United States Department of the Interior

FISH AND WILDLIFE SERVICE

June 19, 1980

This is in response to your letter dated January 23, 1980, requesting consultation pursuant to Section 7 of the Endangered Species Act of 1973, as amended, as to the effects of operation of the Diablo Canyon Nuclear Power Plant (DCNPP) on five endangered species. The original list included the gray whale, Eschrichtius robustus. The gray whale is under the jurisdiction of the National Marine Fisheries Service and will not be considered in this consultation. The remaining species, southern sea otter (SSO), Enhydra lutris nereis; California least tern (CLT), Sterna albifrons browni; California brown pelican (CBP), Pelecanus occidentalis californicus; and the American peregrine falcon (APF), Falco peregrinus anatum, are considered in this examination for potential impacts subsequent to project operation.

Fig. 2. High tide isotherms of thermal plume in Diablo Cove.

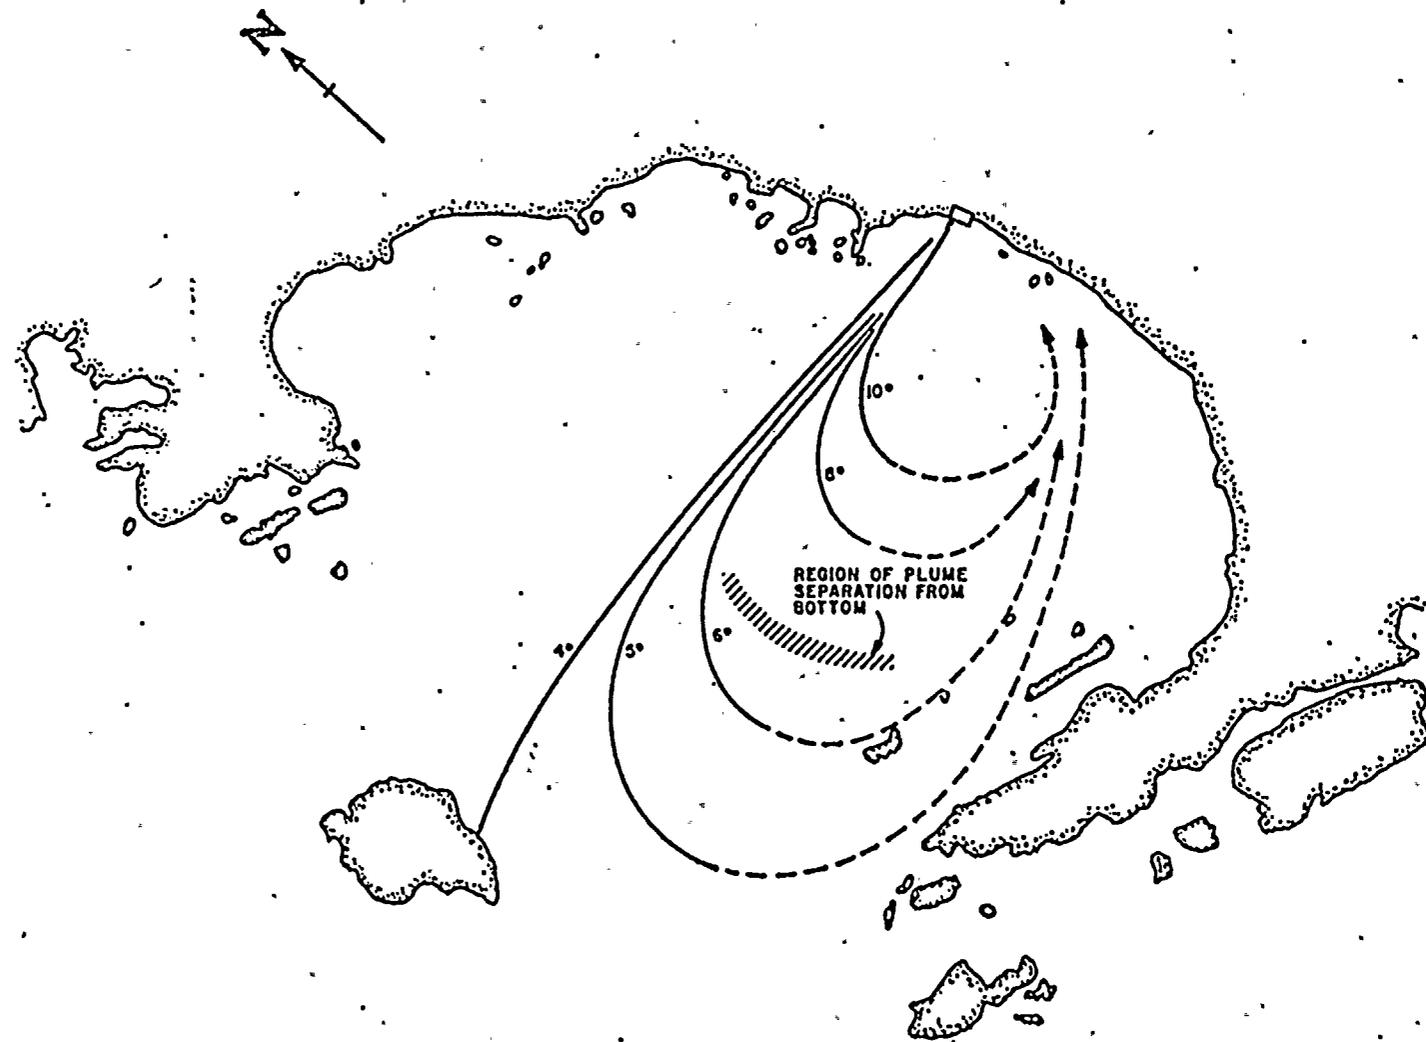
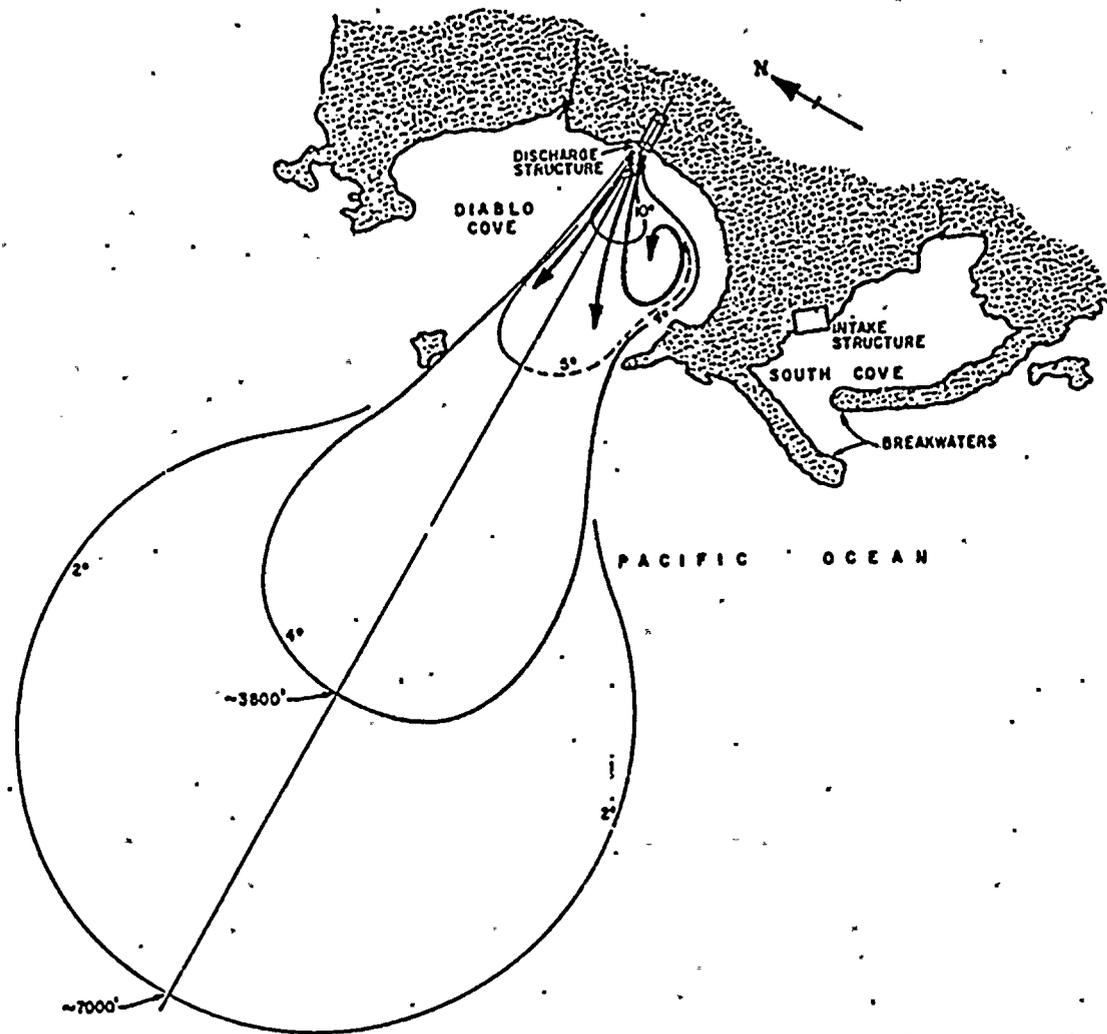
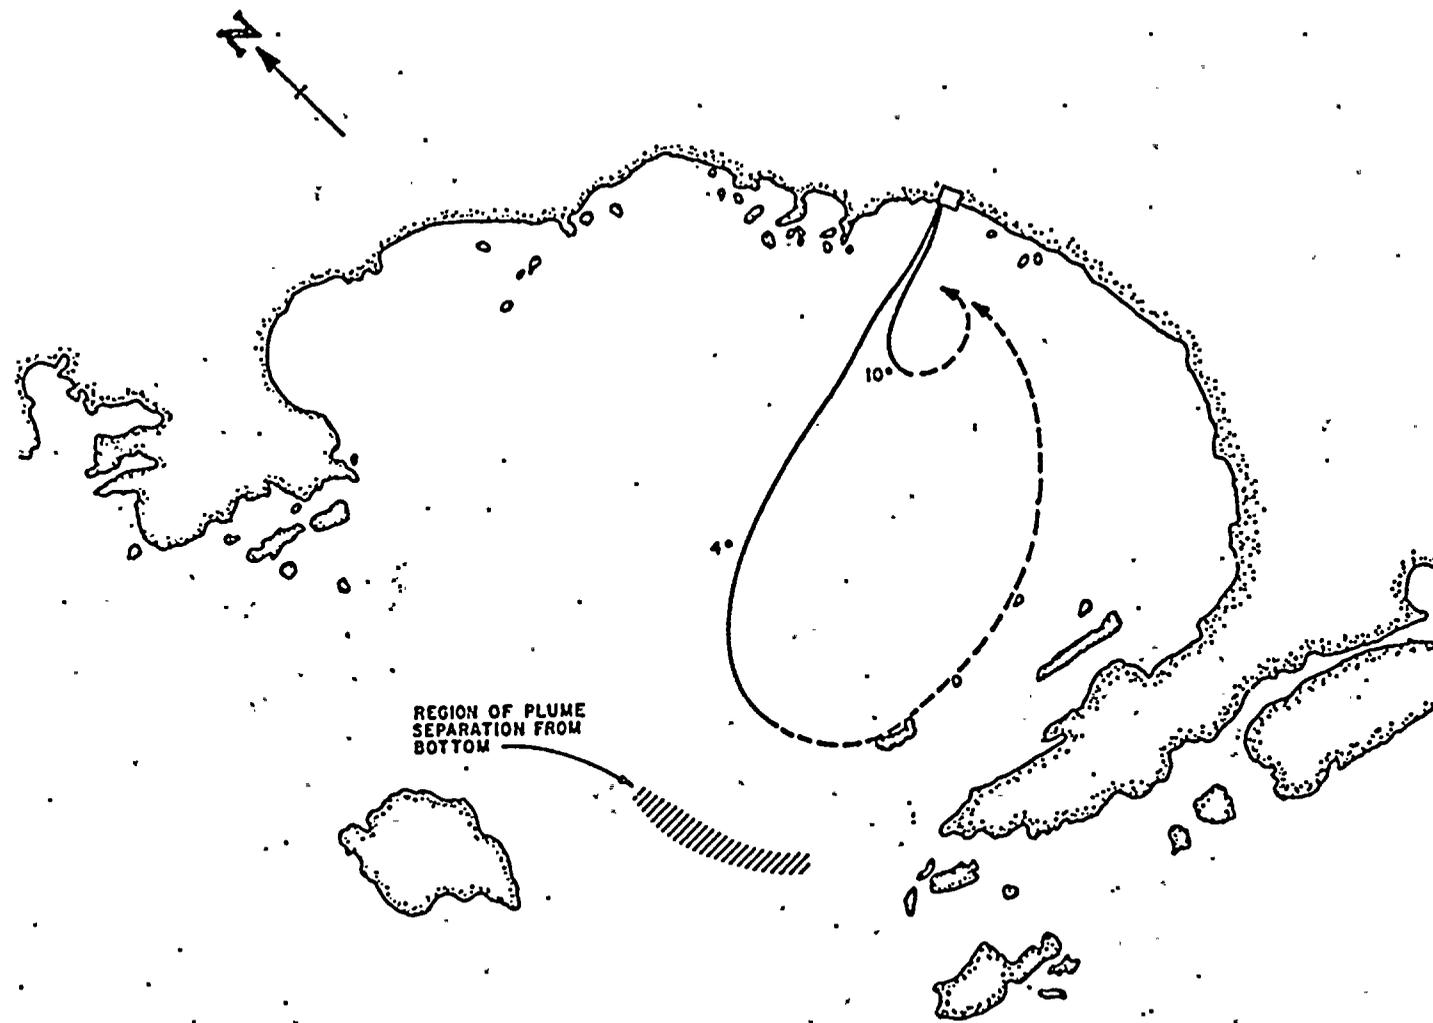
DCNPP is located on a marine terrace in San Luis Obispo County on a remote site that is undeveloped and relatively uninhabited. The coast in this area is rugged with tidal pools and offshore rocks. The cliffs rise steeply from the high water line to the marine terraces. The nearest town is Avila Beach about 7 miles east southeast (Figure 1). Construction began in June 1968 and was subsequently completed. At issue are the potential impacts operation of the facility may have on listed endangered species. Of principal concern are the effects from the cooling water system where seawater is taken in to cool the reactor and then discharged back into Diablo Cove. This heated discharge will dissipate into the cool marine waters. Models have been developed estimating the possible increase in the temperature regime of the local waters. The cooling water flow will be about 3,864 cubic feet per second. The temperature rise through the condenser will be about 19°F. The maximum historical temperature observed in the cove has been 63.5°F. Therefore, the maximum discharge temperature is expected to be 82.5°F. Thermal dissipation is dependent upon tide stages, currents, and sea conditions. An increase in ambient water temperature will affect the local marine community but this change should not be significant. The ranges of thermal dissipation are illustrated in Figures 2, 3, and 4.

5. Examine the thermal plume (both normal operating plume and the superheated, antifouling plume) for extent of direct and indirect impacts on listed species.
